# Northern Runway Programme

Summary of proposed changes to the submitted NRP DCO

December 2023

# Change 1 – an increase to NT IDL extension parameters

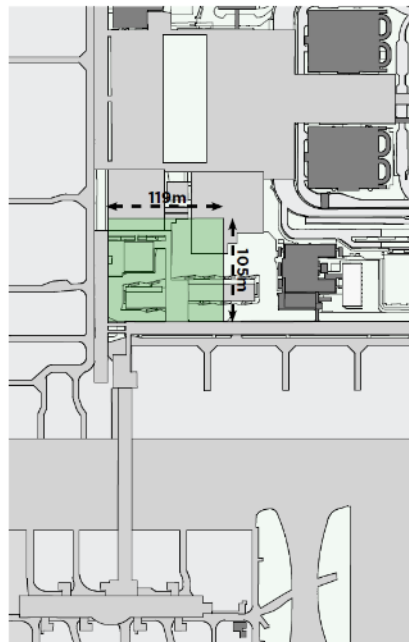
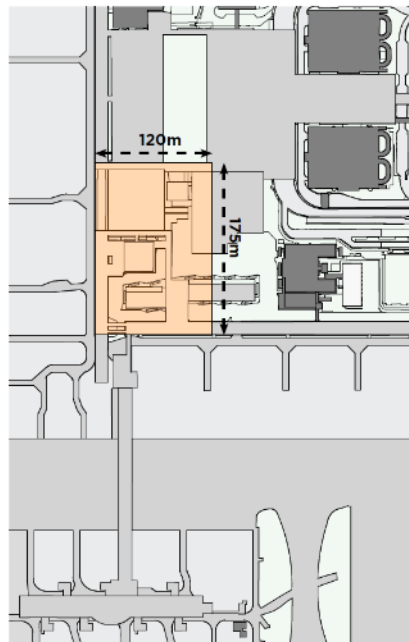
- The proposed southern extension to the North Terminal International Departures Lounge (IDL) will now be contained within a larger design envelope (the orange rectangle) than previously shown (the green rectangle)
- But the new floor area created will remain the same as previously proposed at 12,600m<sup>2</sup>

# Overview of Change 2

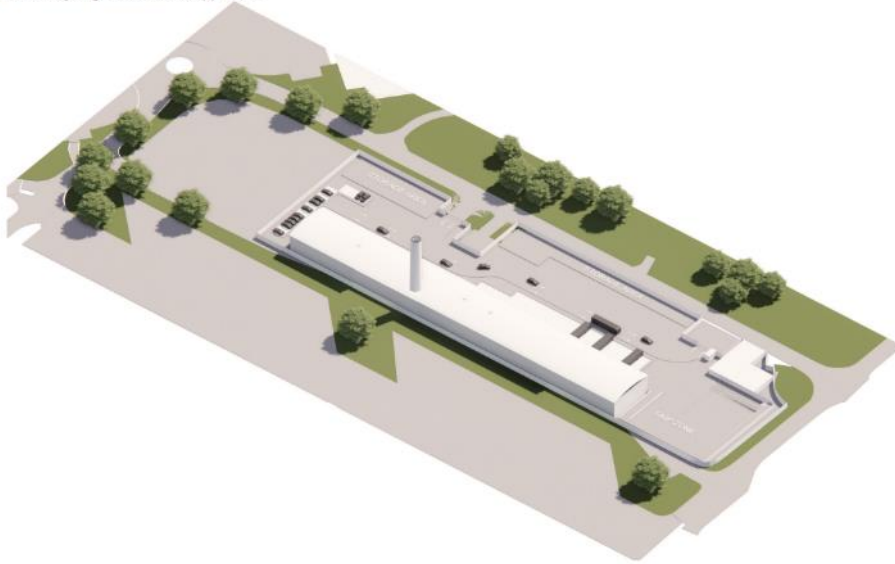
- In line with Gatwick's ongoing drive to sustainability, Project Change 2 proposes the removal of the incineration of waste at the airport by changing the replacement CARE facility to become a waste sorting facility only. Instead, waste material would be taken off-airport to a dedicated waste processing centre(s).
- The change comprises:
  - a decrease in the maximum building height (from 22m to 15m);
  - removal of the biomass flue (48m in height); and
  - removal of two biomass boilers.
- The proposed footprint of the replacement CARE facility building is unchanged, as whilst the biomass boilers would be removed, the space would be required for other recycling activities associated with the CARE facility.

# Location of Change 3

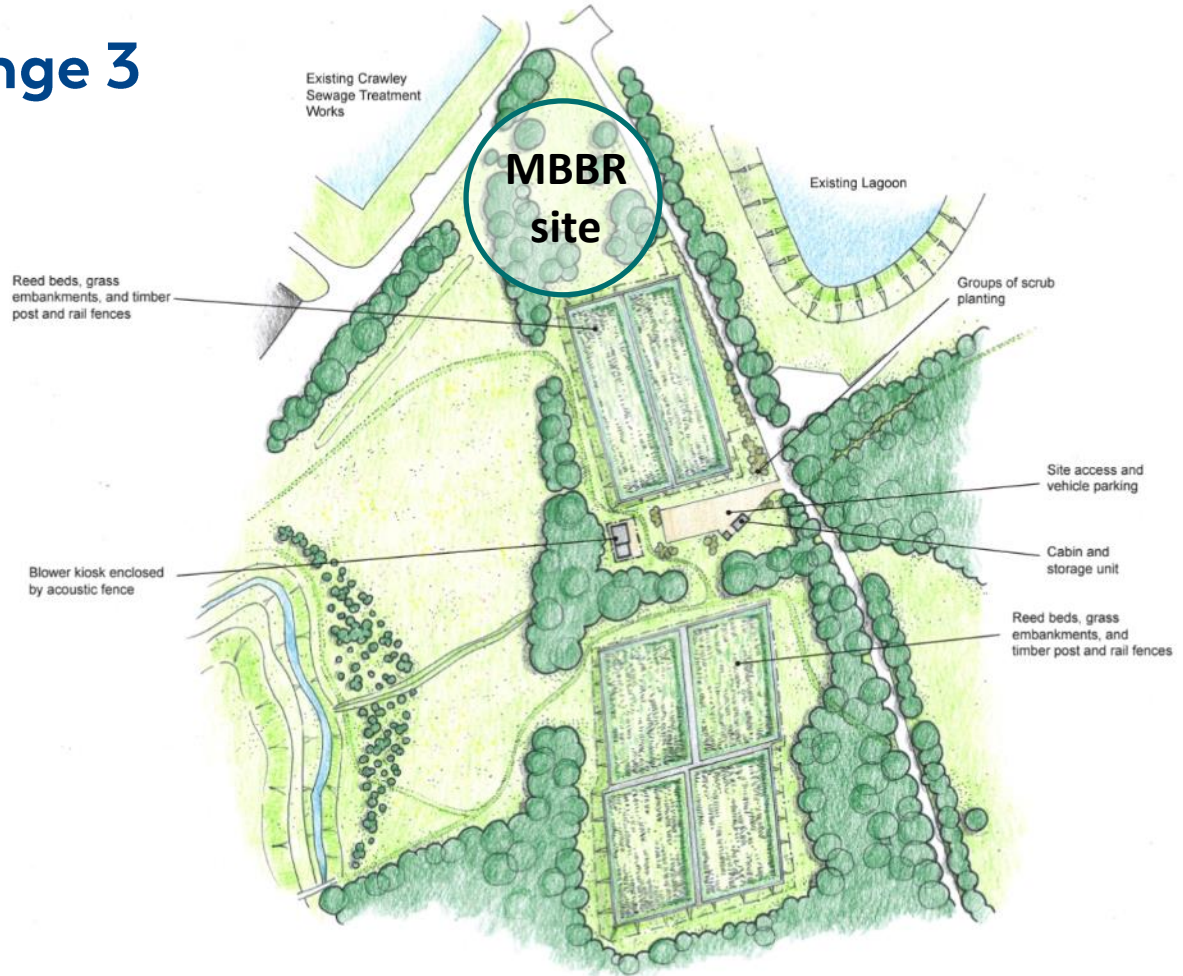
- The DCO Application proposes to treat de-icer contaminated stormwater run-off through a Moving Bed Biofilm Reactor (MBBR) plant.
- Project Change 3 proposes to change this system to a constructed wetland (reed bed) solution, as a more sustainable solution for water treatment in line with Gatwick's sustainability aspirations.
- The area required for the water treatment works would increase from up to 5,600m<sup>2</sup> to approximately 16,000m<sup>2</sup>. The reed beds are proposed to be located to the south of the currently proposed MBBR plant, and south of the existing surface water lagoons (see next slide).
- An additional temporary construction compound (of up to 5,000m<sup>2</sup> in size) will be required for the delivery of the reed bed system.

Current DCO application proposes surface water treatment by MBBR plant (see image of typical installation above)

Change to DCO application proposes surface water treatment by reed bed

These will be located just south of the existing treatment lagoons and the previously proposed MBBR plant site
